# FGI

**Formal Interpretations**  
*Guidelines for Design and Construction of Hospitals, 2018 edition*

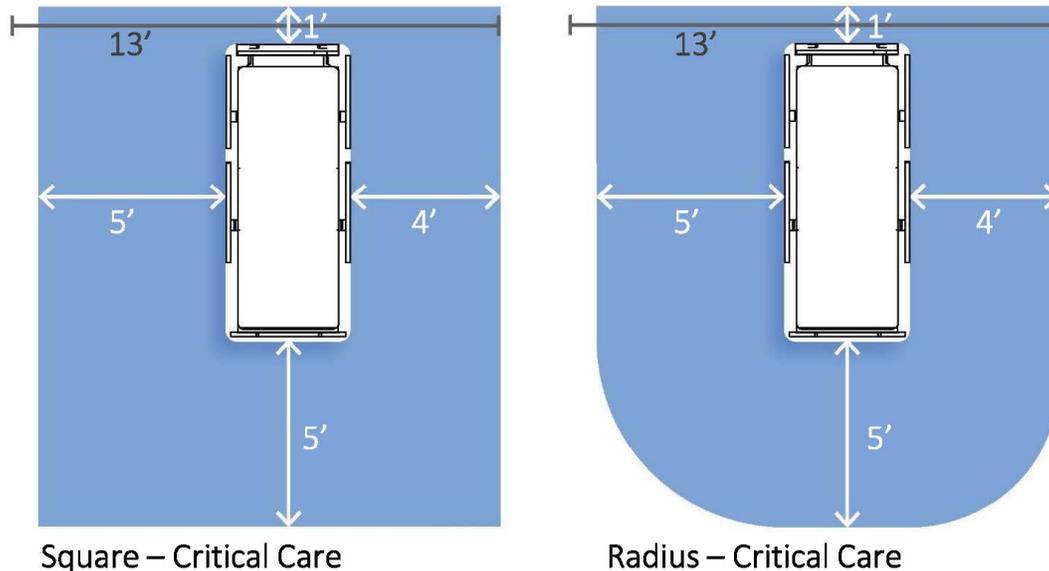
**Question:** In Section 2.2-2.6.2.2 (2), regarding clearances for critical care patient care stations, does the 5-foot clearance requirement at the foot of the bed only require clearance for the width of the bed itself, or is the clearance to be extended to include transfer side width (5 feet) and non-transfer side width (4 feet), such that the width of the clearance at the foot of the bed totals 14 feet?

**Response:** The clearance requirement at the foot of the bed is intended to create sufficient space for care of the patient. Space is needed around the corners of the bed to allow access and movement for equipment, staff, and family members. Staff must be able to easily move around the bed. As well,

space is needed for IV and pain management systems, warmers, etc., and for use of patient lifts and gurneys. To accommodate these needs, the full dimension at the foot needs to be as wide as the clearances on the sides of the bed; however, the squared-off space this creates could be rounded off to accommodate structural or other non-movable encroachments. This response applies to all places in the *Guidelines* where clearance requirements are provided. The diagrams below may help clarify this response.
